Information Processing Center

April 14, 1970

Re: 645 Electrical Problems

ONE LINE BUS OF POWER DIST

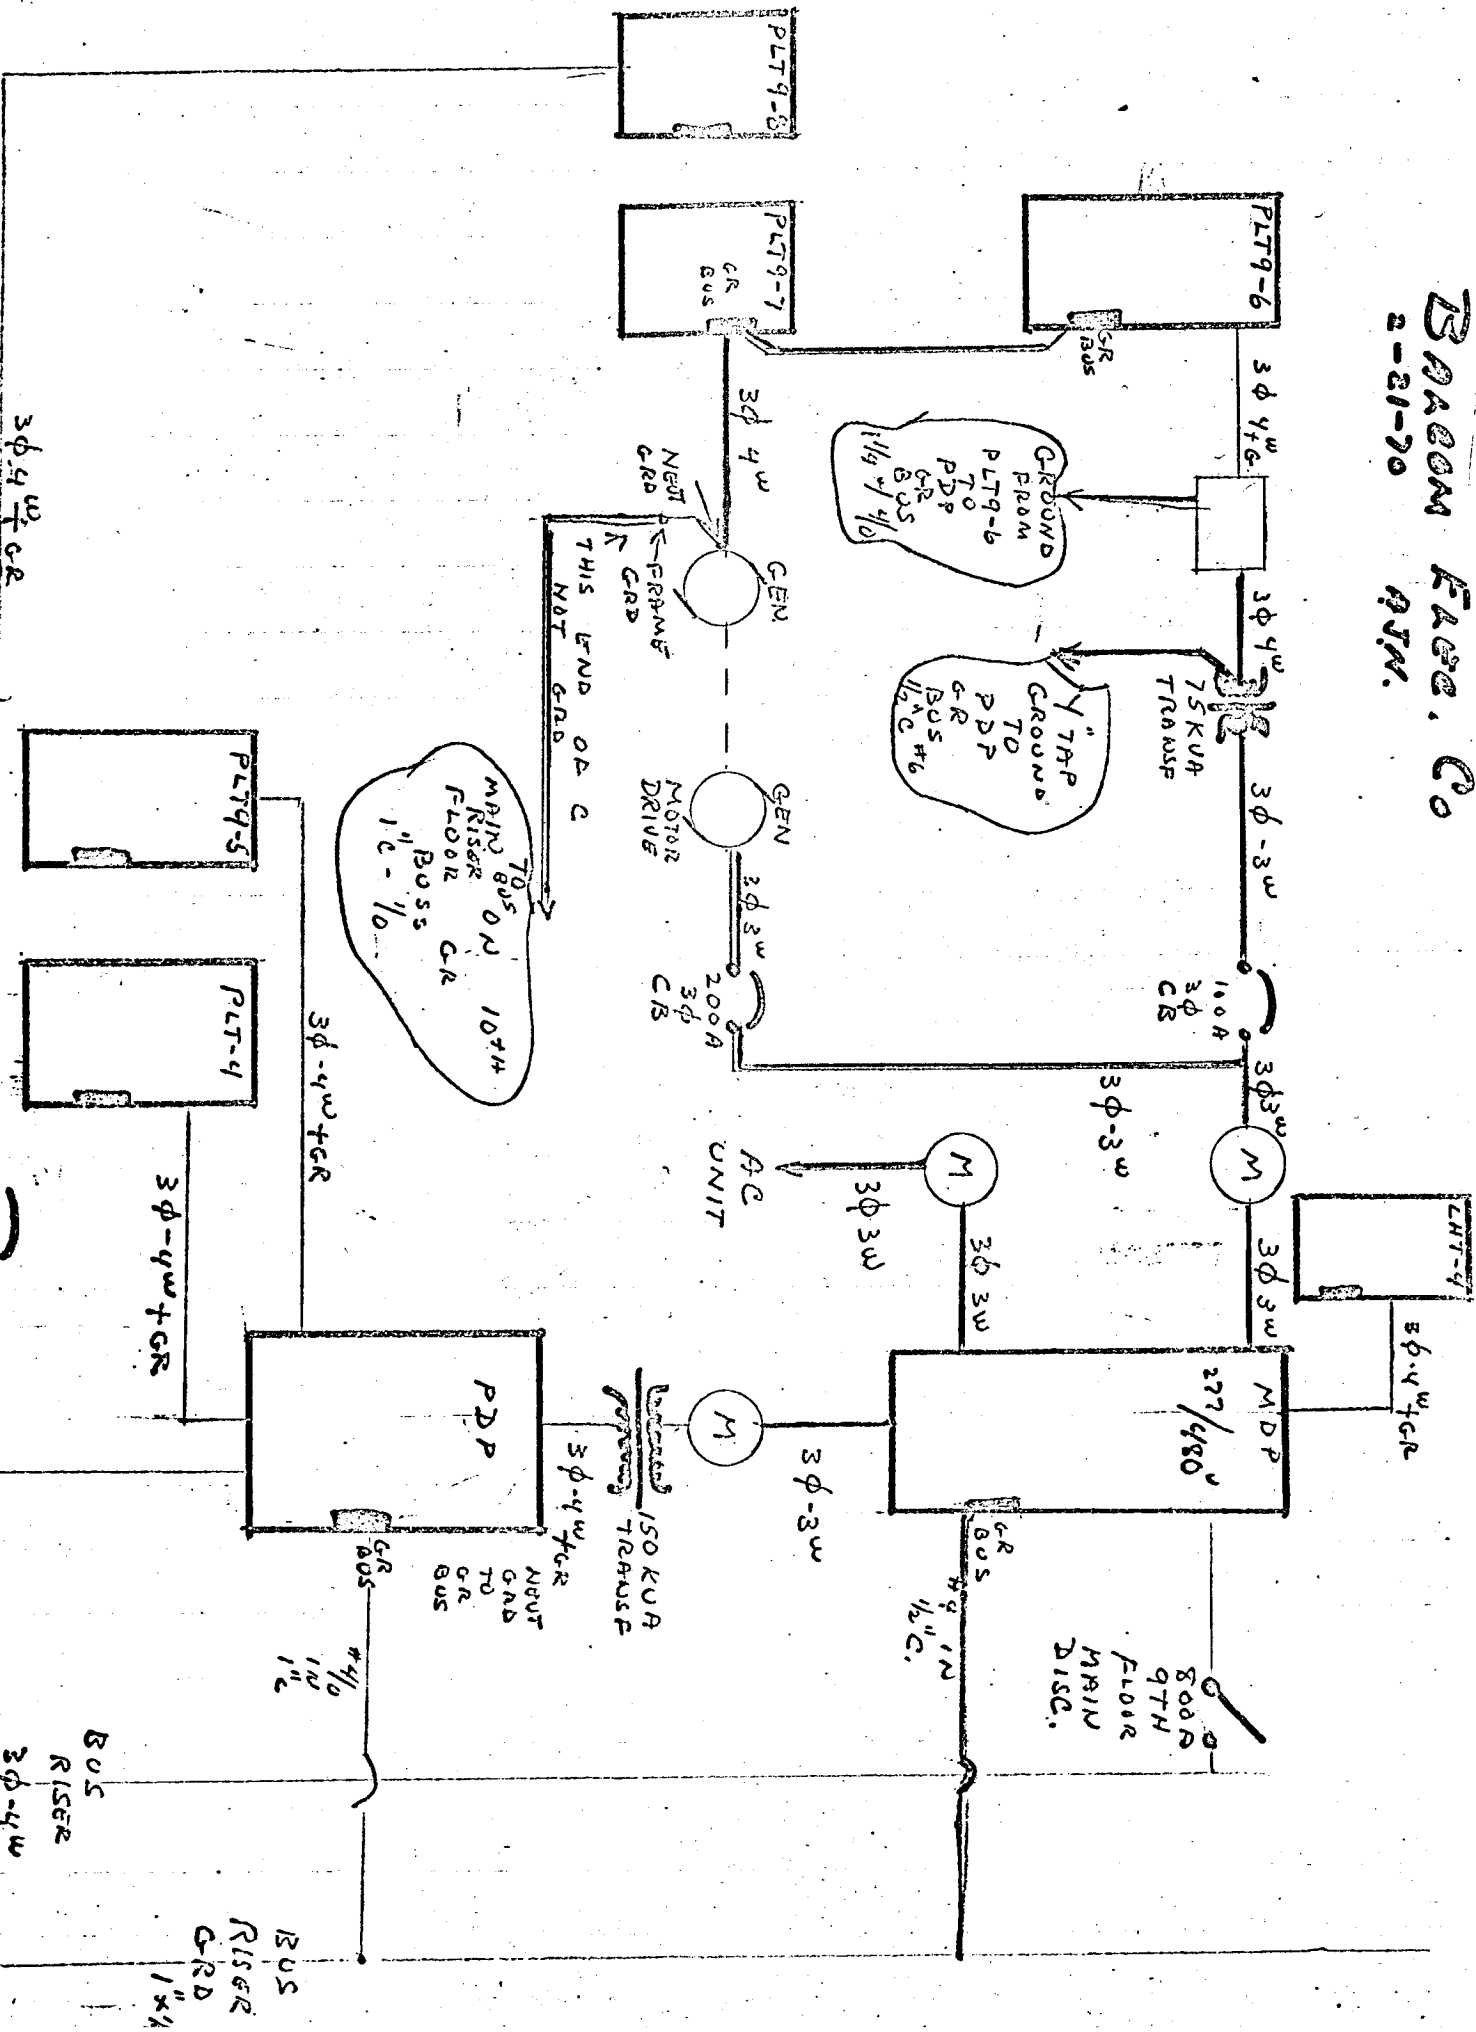
- A. A trace of the ground system was done; a schematic is attached showing the distribution of power from the Main Buses to the various panels, transformers, and the Motor Generator. (Please note that the red lines indicate what we suspect as possible problem areas. A summary of these problem areas is given below.)

1. The ground wire between the main ground bus and the ground point of the MDP should be the same size wire as the main ground bus.
2. The feeder from the MDP to the 100A 3Ø CB and to the 75 KVA transformer should have a ground wire added in the conduit; this would then ground the 75 KVA transformer, the meter, and the 100A 3Ø CB.

The ground wire should be a #2 wire to be consistent with the secondary copper of the transformer.

3. The ground "daisy chain" should be eliminated between PLT9-6 and PLT9-7.
4. The M.G. prime mover should be grounded by bringing a ground conductor, the same size as the generator output from the MDP ground bus to the prime mover of the M.G. unit. The ground for PLT9-7 should be tied onto this ground.
5. The A.C. Motor Control Center feeding the fans, chillers, and pumps should also have a ground.
6. Remove jumper in Main Switch Board located in basement, the jumper now runs from Neutral to ground and frame ground. The tie point should be made closer to the entrance of the ground wire and neutral bus as they come into the building.
7. A separate ground could be run from all the Computer Equipment to the Main Ground in the basement.

RED LINES INDICATE PROBLEM AREAS.
